Re: Special Permit Application – 164 Grove Street, Franklin, MA

PERMIT SITE DEVELOPMENT PLANS

DATE: MAY 21, 2020
SCALE: 1" = 30'
PROJECT: UC1435
SHEET: 4 of 9

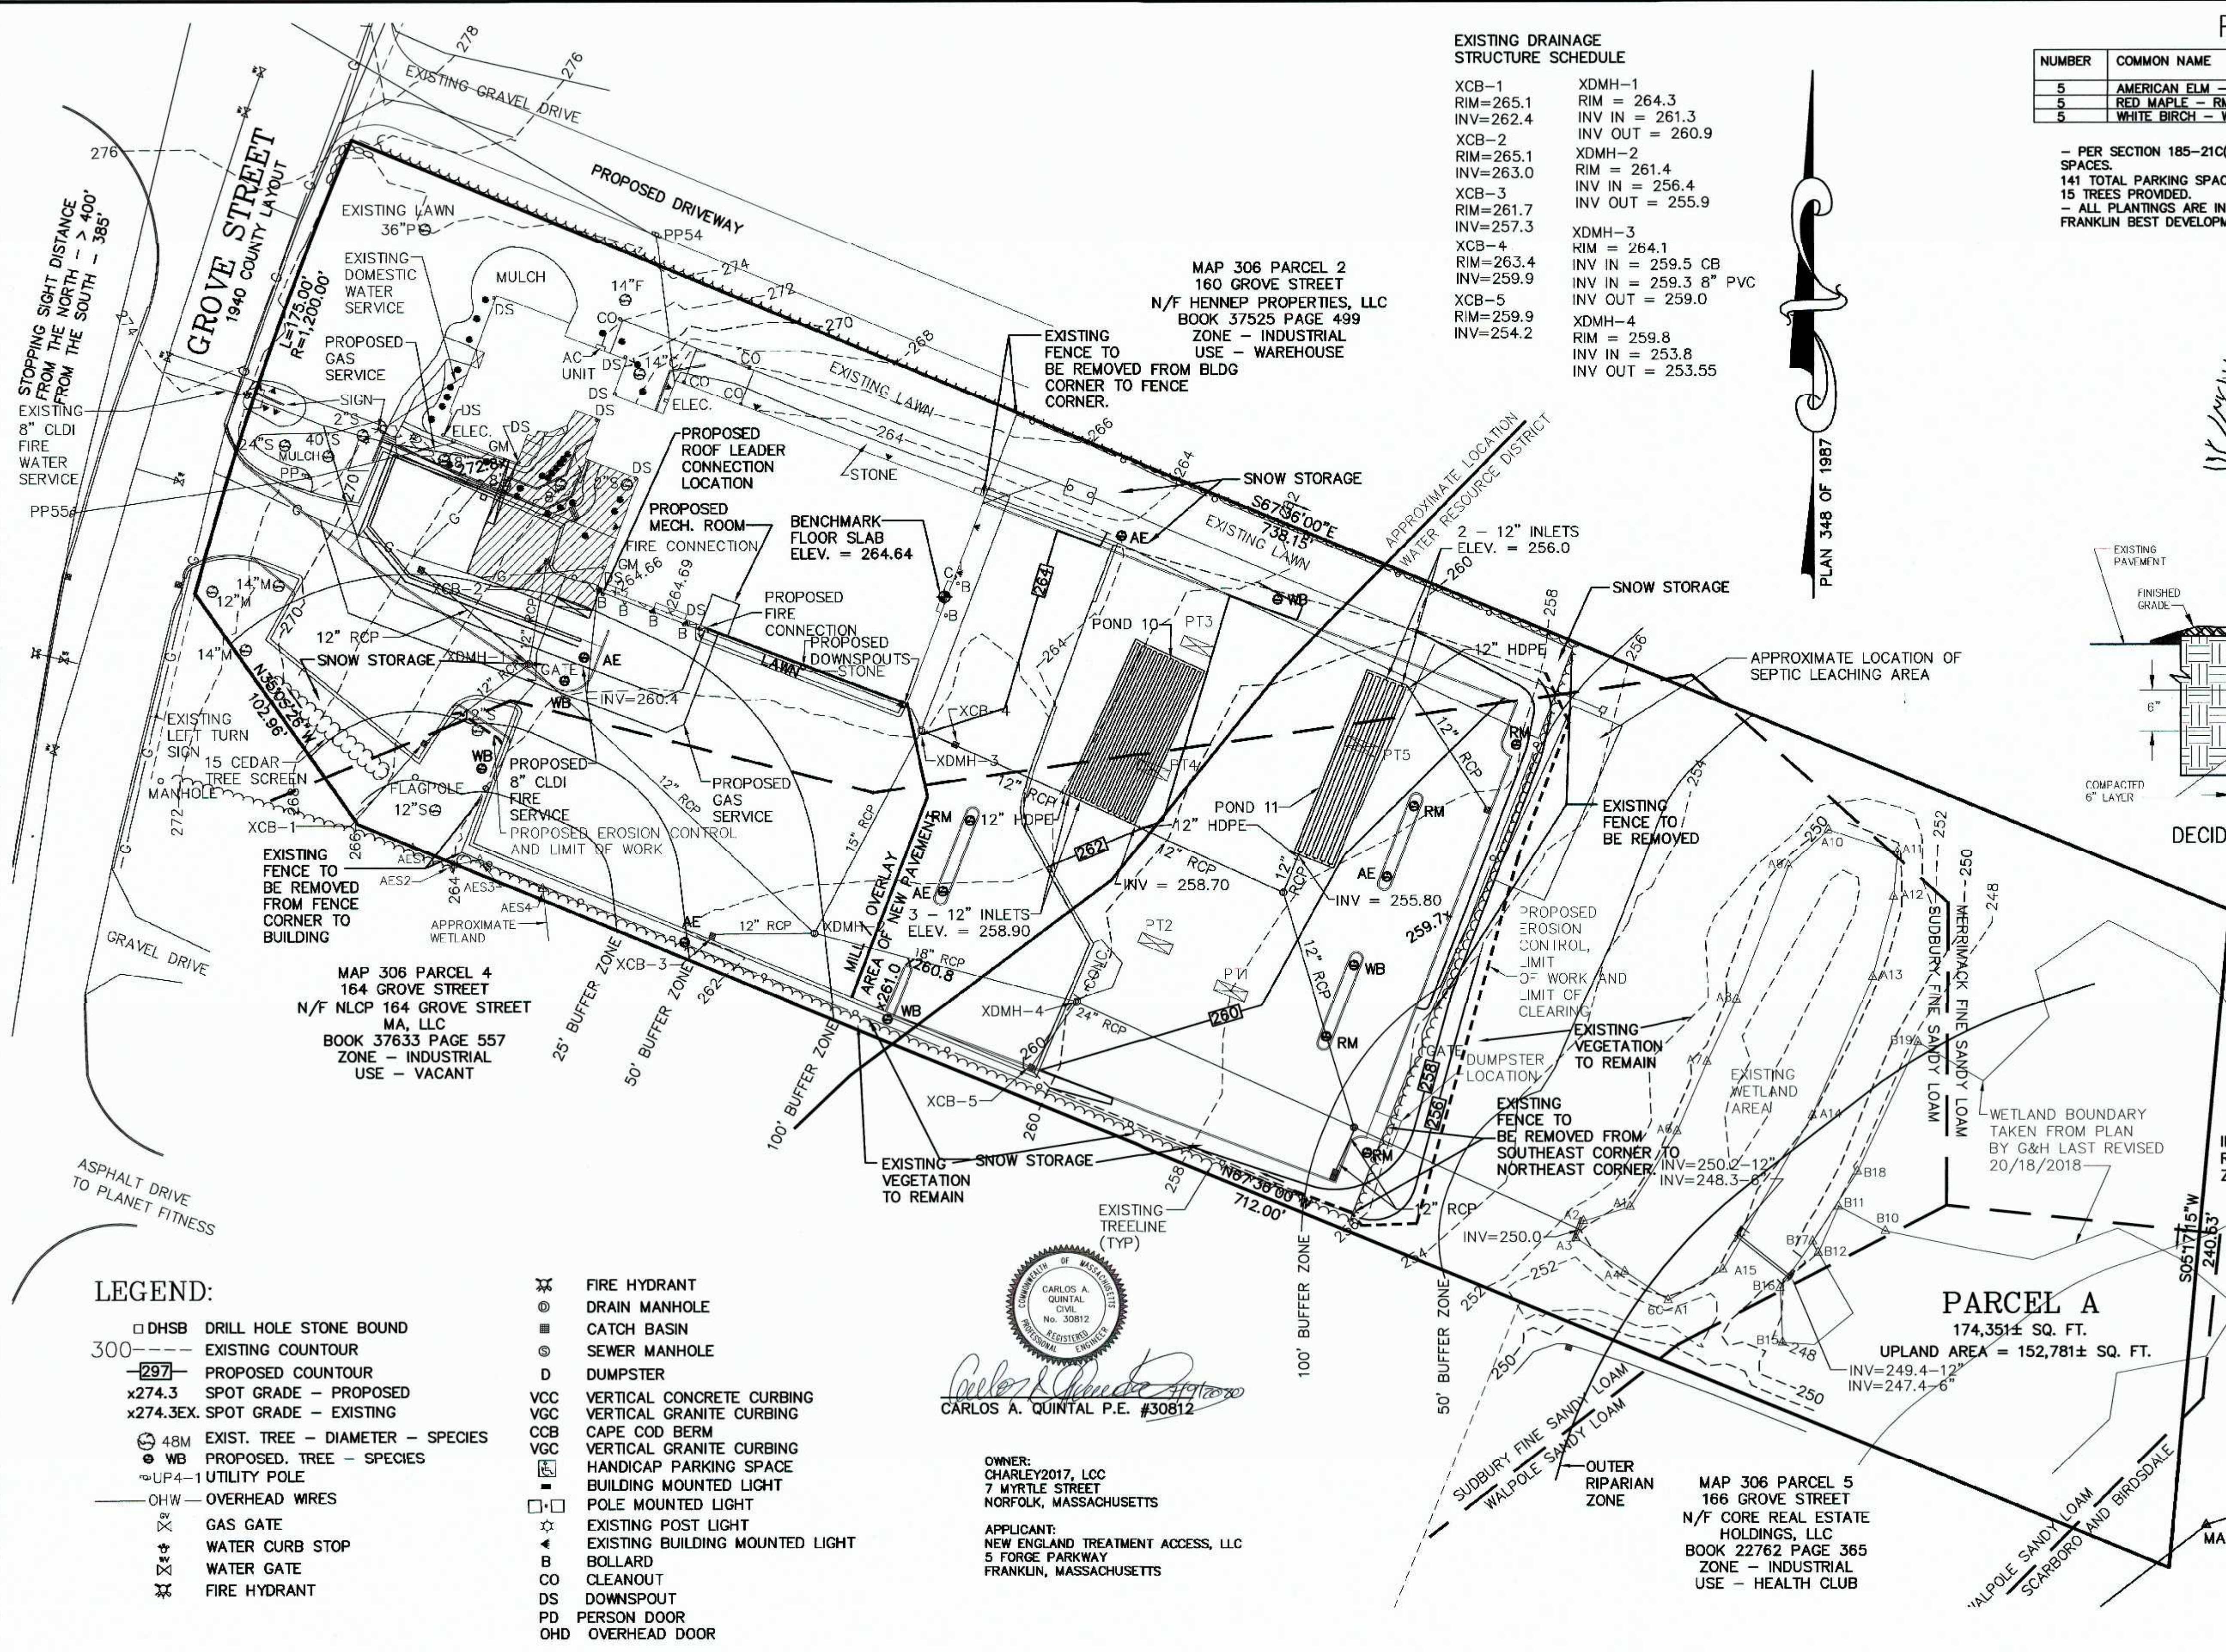
- G5. Indicate the limits of new pavement, pavement reconstruction, or any mill/overlay. *UCI: The limits of new paving/mill have been labeled on sheet 4.* **BETA2: Information provided – issue resolved.**

- S2. Indicate proposed snow storage locations on the plans (§185-31.C.(3)(i)). *UCI: Snow storage areas have been added to sheet 4. A note referencing zoning bylaw section §185-40D(1)(j) has been added to sheet 4.* **BETA2: Snow storage areas provided – issue resolved.**

- S4. Depict existing tree line and limits of clearing on the plans, as applicable (§185-31.C.(3)(u)). *UCI: The existing tree line and the limit of work label has been revised to include limit of clearing on sheet 4.* **BETA2: Information provided – issue resolved.**

- WR1. Confirm the estimated sewage flow for the on-site disposal system does not exceed 110 gallons per 10,000 sq. ft. of lot area (§185-40.D.(1)(i)). *UCI: The requested confirmation and supporting calculations have been added to sheet 4.* **BETA2: Information provided – issue resolved.**

- WR4. Note that any fill placed in quantity greater than 15 yards must be certified in accordance with §185-40.E.(5). *UCI: The requested note has been added to sheet 4.* **BETA2: Note provided – issue resolved.**

- SW2. Recommend labeling which drainage structures and pipes are to be removed/abandoned. *UCI: The removal protocol for the existing 15" RCP pipe connecting X-DMH3 to X-DMH2 has been added to the stormwater system construction note 3 on sheet 4.* **BETA2: Information provided – issue resolved.**

SW9. As no mottling was observed in the test pits, a Frimpter Analysis should be conducted to adjust observed weeping to an estimated seasonal high groundwater elevation. BETA estimates the separation to ESHGW from the bottom of the proposed infiltration structures is approximately 2+ feet. *UCI: The Frimpter adjusted ESHGW elevations were added to the soil logs on sheet 4.* **BETA2: Information provided – issue resolved.**

3. It appears that a portion of the proposed parking lot is being extended and some other areas are being reconstructed. Please identify the limits of paving on the plans and if some areas are to remain in their existing condition.
The limits of new paving and mill / overlay have been labeled on sheet 4.

4. It is unclear what is being proposed for the 15" RCP between existing DMH#2 and 3.
Storm water system construction note #3 has been added to sheet 4 to address the 15" pipe abandonment.

The limits of new paving / mill and overlay have been labeled on sheet 4.

Snow storage areas have been added to sheet 4. A note referencing zoning bylaw section 185-40D.(1))f) has been added to sheet 4.

The existing tree line and the limit of work label has been revised to include limit of clearing on sheet 4.

The requested confirmation and supporting calculations have been added to sheet 4.

The requested note has been added to sheet 4.

The removal protocol for the existing 15" RCP pipe connecting X-DMH3 to X-DMH2 has been added to the stormwater system construction note 3 on sheet 4.

The Frimpter adjusted ESHGW elevations were added to the soil logs on sheet 4.

DUMPSTER AREA GRADING DETAIL
N.T.S.

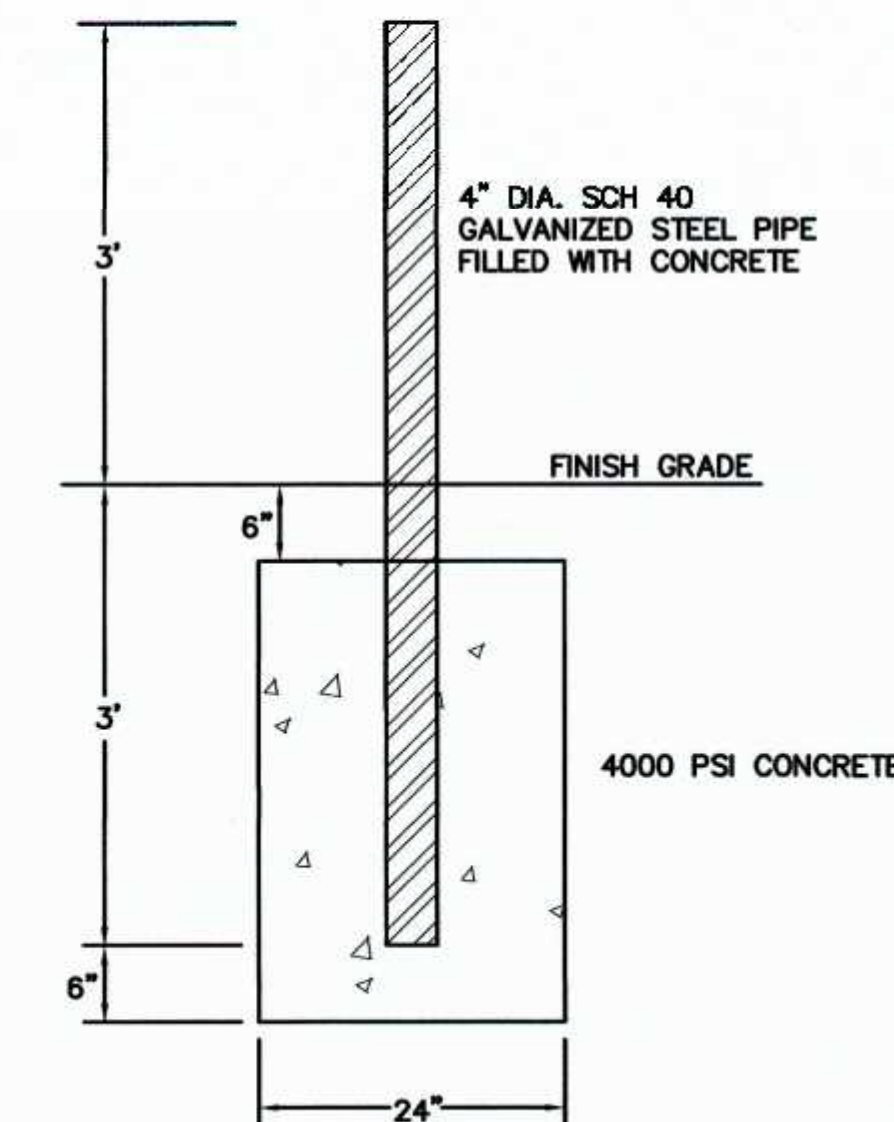
- SW4. Provide detailed grading in the area of the dumpster pad to ensure stormwater flow is not directed through the enclosure, bypassing the stormwater management system. *UCI: A dumpster grading detail was added to sheet 8.* **BETA2: Grading detail provided – issue resolved.**

A dumpster area grading detail was added to sheet 8.

SITE PLAN
 CONSTRUCTION DETAIL - 2
 162 GROVE STREET
 FRANKLIN, MASSACHUSETTS
 PREPARED FOR
 NEW ENGLAND TREATMENT ACCESS, LLC
 5 FORGE PARKWAY
 FRANKLIN, MASSACHUSETTS
 MAY 21, 2020
 SCALE: 1" = 30'

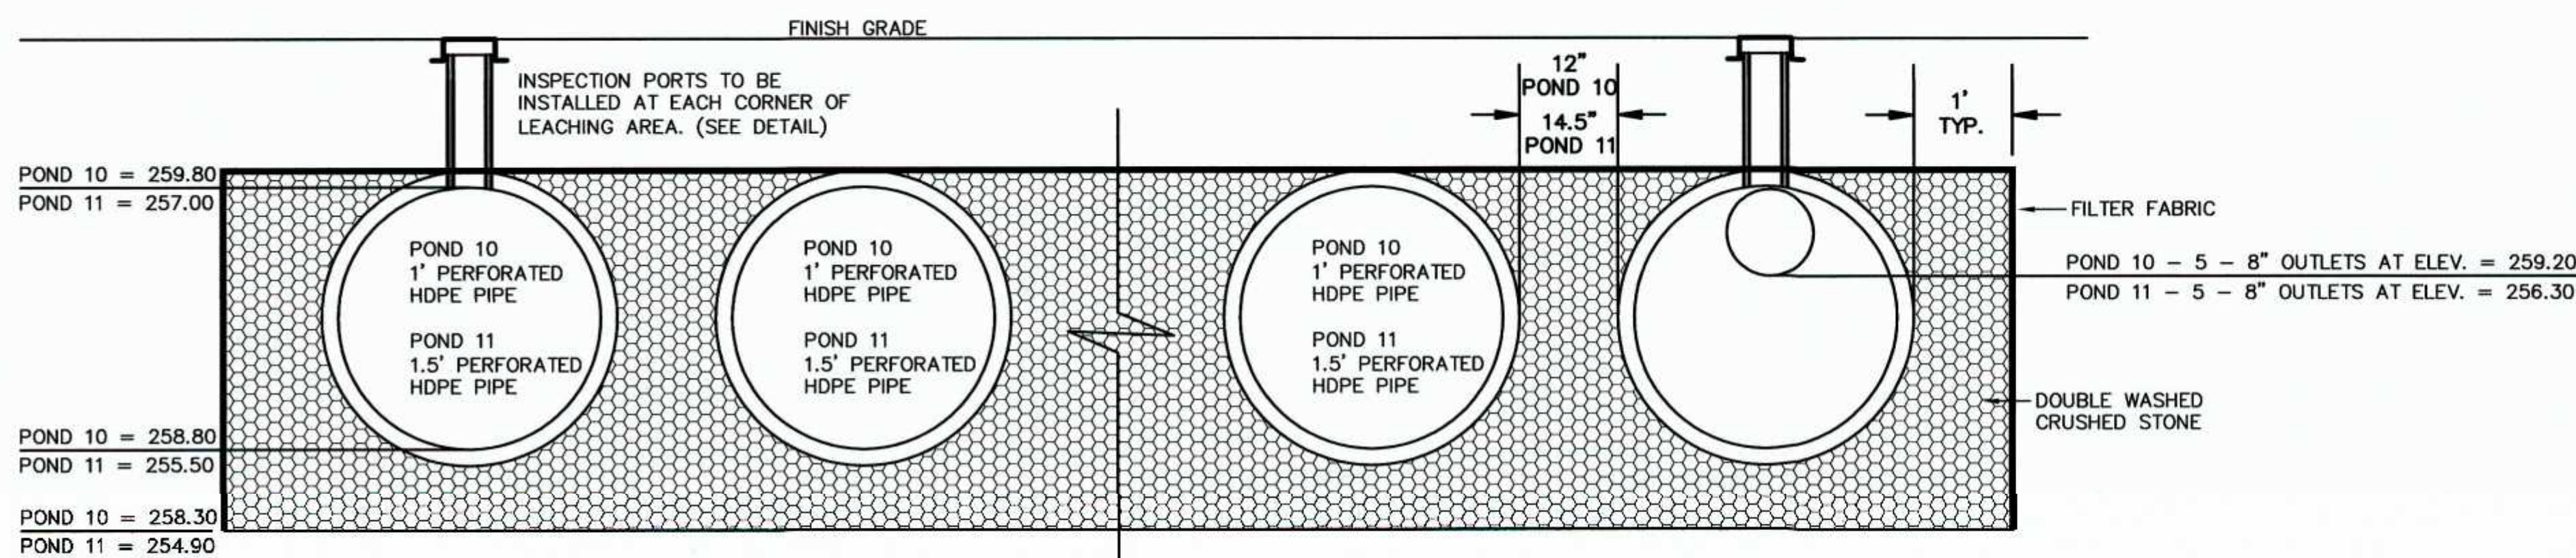
- G1. Provide safety fencing along the top of wall on the western end of the courtyard area that abuts the exiting walkway. *UCI: The proposed fence location has been added to the detail on sheet 9.* **BETA2: Fencing provided – issue resolved.**

- P2. Clarify if the proposed walkway will be reconstructed with concrete as shown on the Courtyard Area Detail or will remain bituminous concrete. *UCI: The proposed 8 foot wide walkway located southerly of the existing building will remain bituminous concrete. The limits of concrete and bituminous concrete have been labeled on the additional entry and accessible route detail on sheet 9. BETA2: Clarification provided – issue resolved.*

The proposed fence location has been added too the detail on sheet 9.

The proposed 8 foot wide walkway located southerly of the existing building will remain bituminous concrete. The limits of concrete and bituminous concrete have been labeled on the addition entry and accessible route detail on sheet 9.
